**Summary of Response to Public Comments  
Kings River Project DEIS, Sierra NF**

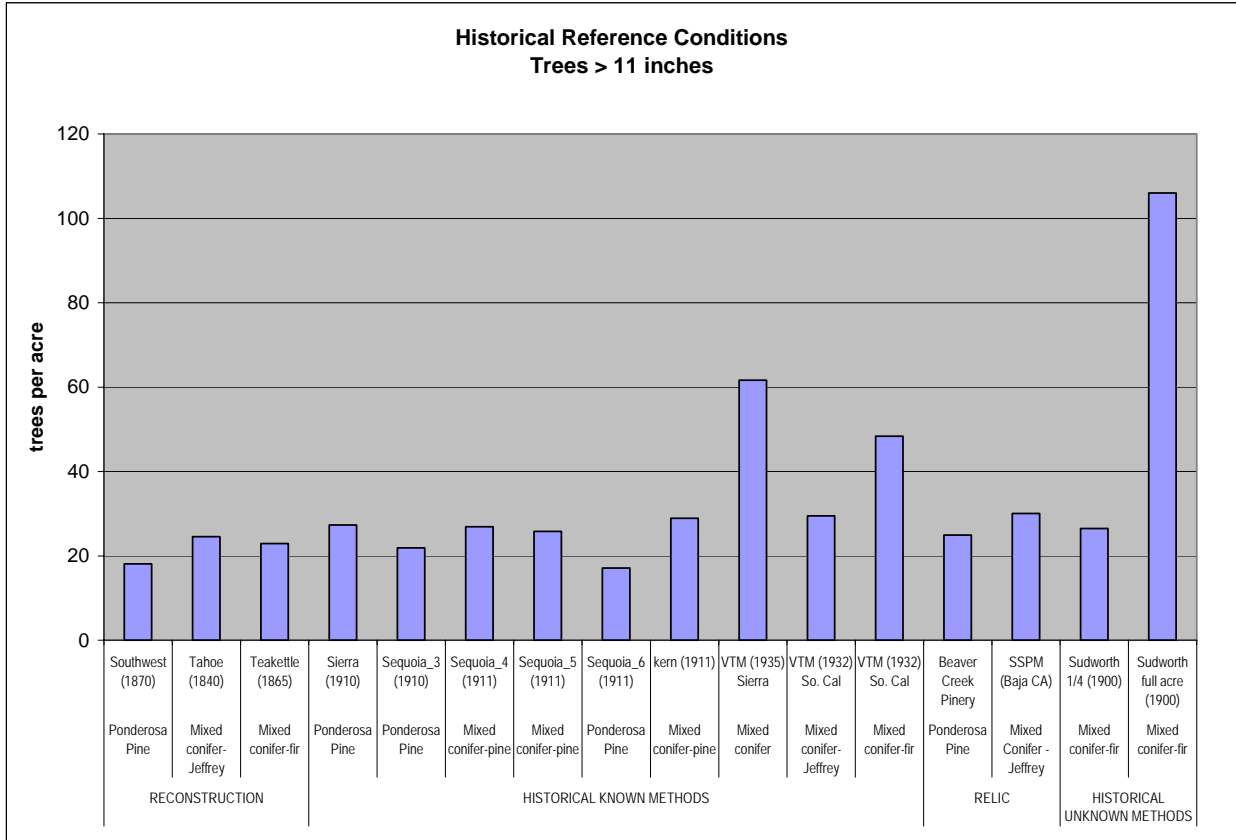
Another main point is the inverse J-curve is a result and not a process so its imposition does not by itself create uneven-aged stands or structures representative of the historical forest. We agree that simply imposing an inverse J-curve does not create uneven-aged or historical forest structures. These structures result from partial disturbance, the retention of different existing age classes and the creation of new reforestation groups. The inverse J-curve as defined by the BDQ method is a tool. In the field, application requires choices between species, crown position, age class and size. Crown position requires the recognition of different cohorts in the matrix so that suppressed and intermediate trees are not selected to remain, age class division in the matrix can be accentuated and layering can be developed for wildlife habitat objectives. A minimum basal area target is required to maintain structure and disperse removals across the stand. The J-curve supplies removal or retention targets for the 11 to 35 inch diameter classes. Reforestation groups are created in existing openings and/or groups of small trees are utilized were they exist. Large trees, those greater than 35 inches in diameter, are retained. Prescribed fire is then applied were appropriate and functions as a tool to reduce fuel accumulations, kill small cedar and fir trees and brush and reinitiate frequent fire. The fire is important to the inverse J-curve distribution because it tends to depress the number of small trees in the distribution.
